INSTRUCTION MANUAL

**430 GENERAL-PURPOSE
3" OSCILLOSCOPE**

MODEL PLC PROBE ADDENDA

LOW CAPACITY PROBE-CONSTRUCTION ADDENDUM

Figure 11. Model 430 Schematic Diagram

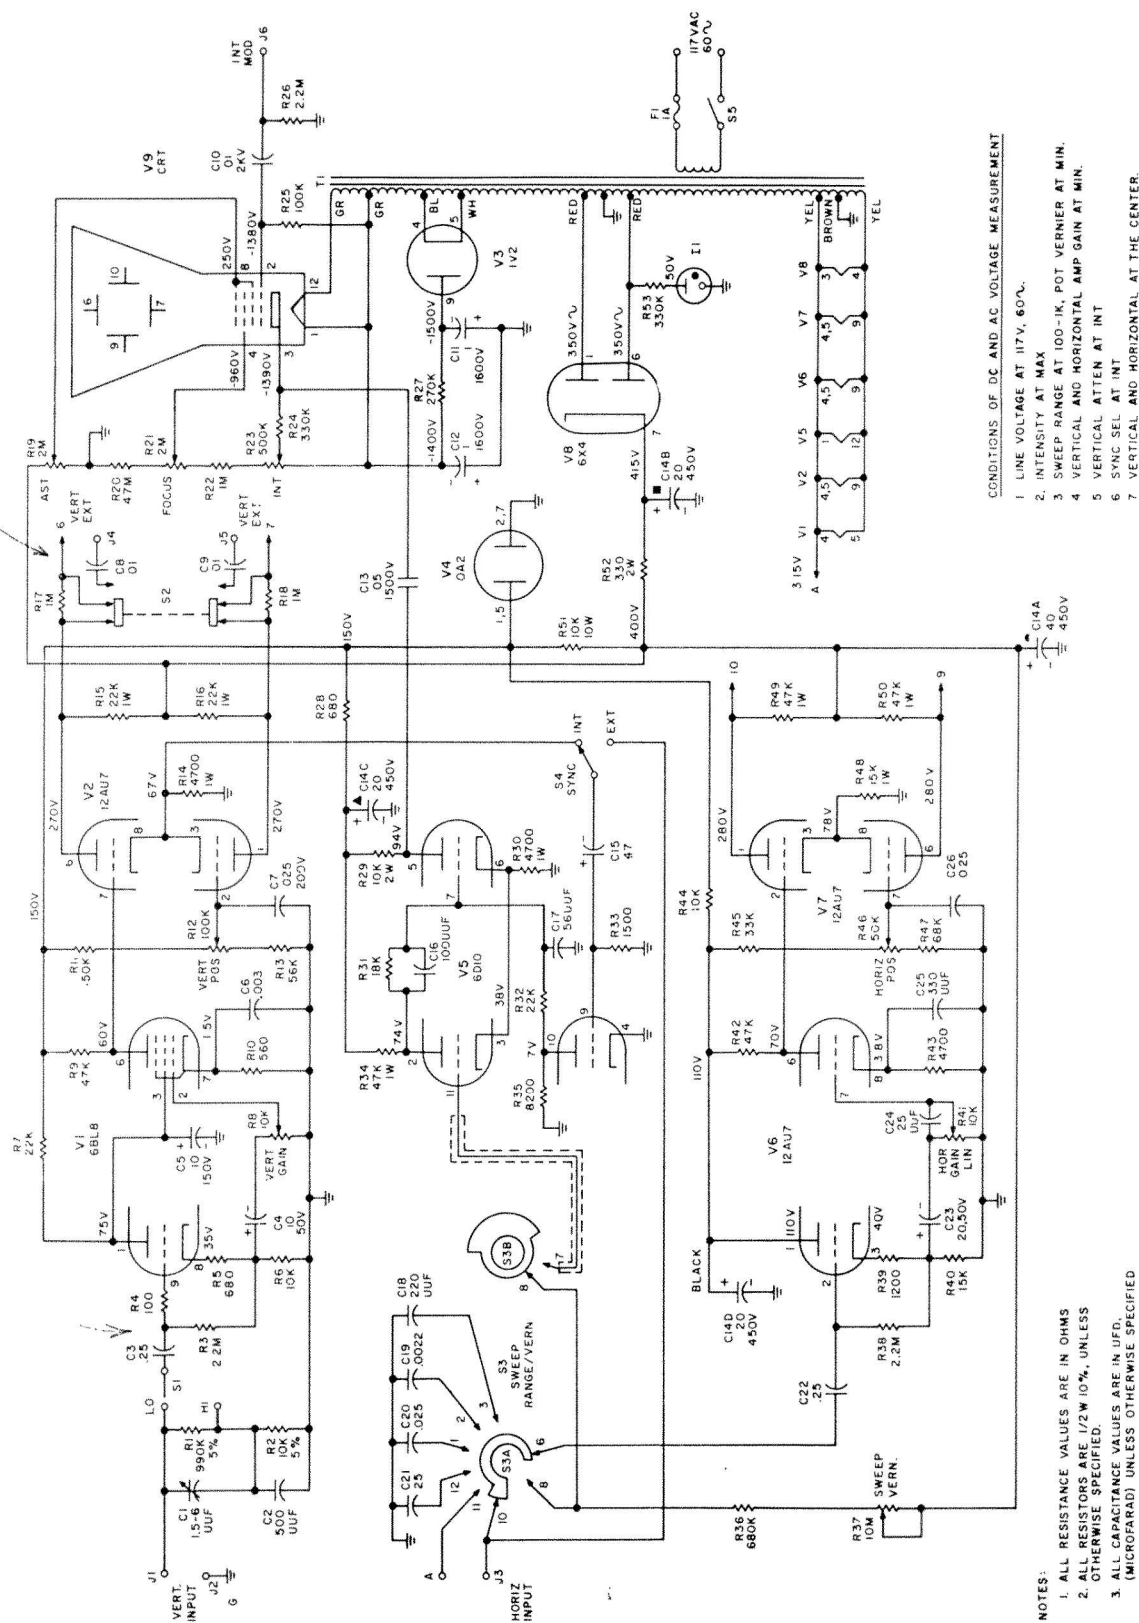
Page 22, Schematic Diagram: Change R15 and R16 from 1W to 2W
Change R33 from 1500 Ω to 150K Ω
Change C26 from .25ufd to .025ufd
From V7 pin #1 at the end of the arrow change #10 to #9.
From V7 pin #6 at the end of the arrow change #9 to #10.
From R17 at the end of the arrow change pin #6 to pin #7.
From R18 at the end of the arrow change pin #7 to pin #6.

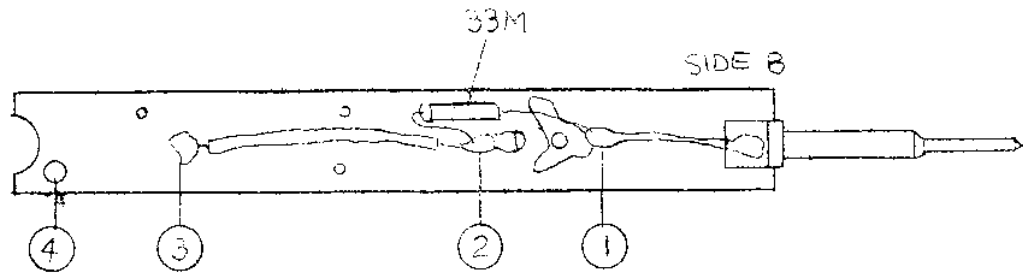
Please use the following illustration in place of Figure 4 when wiring the 33M ohms resistor to the trimmer capacitor leads. NOTE that resistor is repositioned to permit the assembly to be inserted easily into the probe housing.
